Proposed Marlborough Environment Plan

**Section 42A Hearings Report for Hearing Commencing 21 May
2018**

**Report on submissions and further submissions
Topic: 20 - Utilities and Designations**

Figure 3: Planning Map - North of the Elevation in Picton

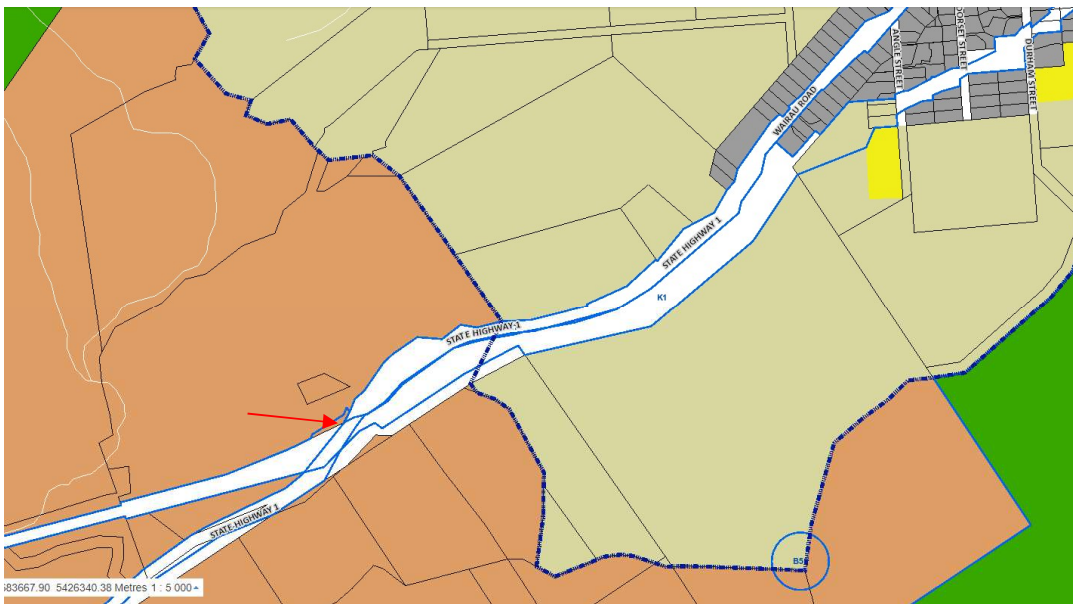
- (873.198 & 873.199) To the north of the Elevation in Picton (underlying Rural zoning) – I have confirmed with the submitter that there are two areas of land to which this relates, shown in the following figures. The first (refer red arrow in Figure 3) is a small portion of rural-zoned land adjacent to the rail, where the State Highway and railway cross. In my view, due to its shape and size, it is unlikely to be utilised for any other purpose and to include it within the unzoned rail corridor is appropriate. The second area (refer red star in Figure 4) is zoned Coastal Environment and located at the southern entrance to Picton. It is a much larger portion of land that is adjacent to Urban Residential 2 zoned land. Aside from the railway line itself, it does not appear to currently contain any activity, and in my view, it would not generally be appropriate to allow for any land use activity within the area to occur without regulation (which is the effect the un-zoning would have). I do consider that this is finely balanced however, as I note that there are other relatively wide portions of the rail corridor in the vicinity (and adjacent to urban-zoned land) that are unzoned and also currently undeveloped aside from the railway line itself. I agree that the area containing the railway tracks should be unzoned as it is an anomaly for this area to be zoned. My recommendation is therefore to ‘unzone’ the railway line (and the area beyond this to the south, that is within the designation), but retain the Coastal Environment zoning for the portion of vacant land beyond this to the north, that is adjacent to the Urban Residential 2 Zone (refer red line in Figure 4).

283. Amend Planning Map 135 to identify designation E29.¹⁰⁷
284. Amend Planning Maps 14 and 159 to remove Section 229 Omaka District from Designation C32.¹⁰⁸
285. Delete Designation B16 from the Marlborough District Council designation schedule (page 14-5) and consequentially remove from Planning Maps 58 & 186.¹⁰⁹
286. Amend Planning Maps to unzone portion of land identified with red arrow in Figure 1 above.¹¹⁰
287. Amend Planning Maps to unzone portion of land identified with red arrow in Figure 3 above.¹¹¹
288. Amend Planning Maps to unzone portion of land identified with red star in Figure 4 above, below the red line.¹¹²
